Access Compliance Report Public Rights-of-Way (Curb Ramps)

Main Street: VINEVALE_ST Cross Street: PACIFIC_AVE Location: NE

ADA ID: RPRK210921172352 Ramp Type: Type 1 - Perpendicular Diagonal Initial Pass/Fail: Fail Overall Compliance: No Severity Score: 2

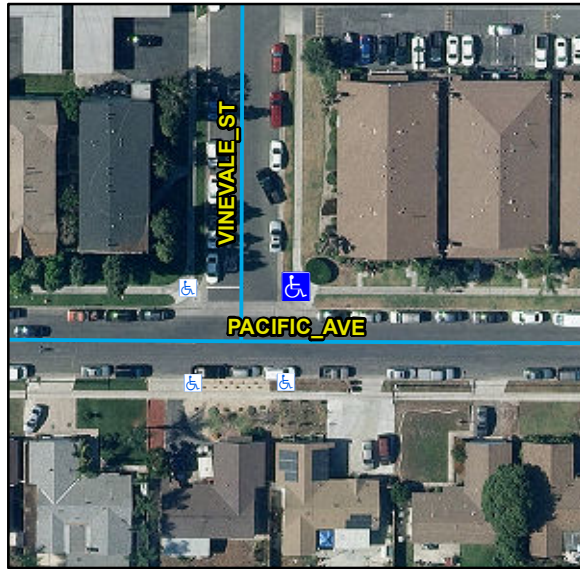
N/A	Ramp Inside Crosswalk 1	N/A	Yes	Ramp Inside Crosswalk 2	N/A
	Crossing 1 Slope (%)	2.9		Crossing 2 Slope (%)	0.5
	Crossing 1 Cross Slope (%)	0.9		Crossing 2 Cross Slope (%)	0.3
N/A	Gutter Ponding	N/A	No	Curb Slope	8.2
Yes	Gutter Lip Height (in)	0		Road Run Slope (%)	1.2
N/A	Gutter Run Slope (%)	N/A		Road Cross Slope (%)	2.1
N/A	Gutter Cross Slope (%)	N/A			
Yes	Overall Surface Condition: Acceptable		Yes	Perp Joint Present	Yes
	Cross Gutter Present?	Yes		Spandrel Present?	Yes
	Replace Cross Gutter?	No		Replace Spandrel?	No

Remove & Replace Curb Ramp With Two New Directional Ramps or Equivalent.
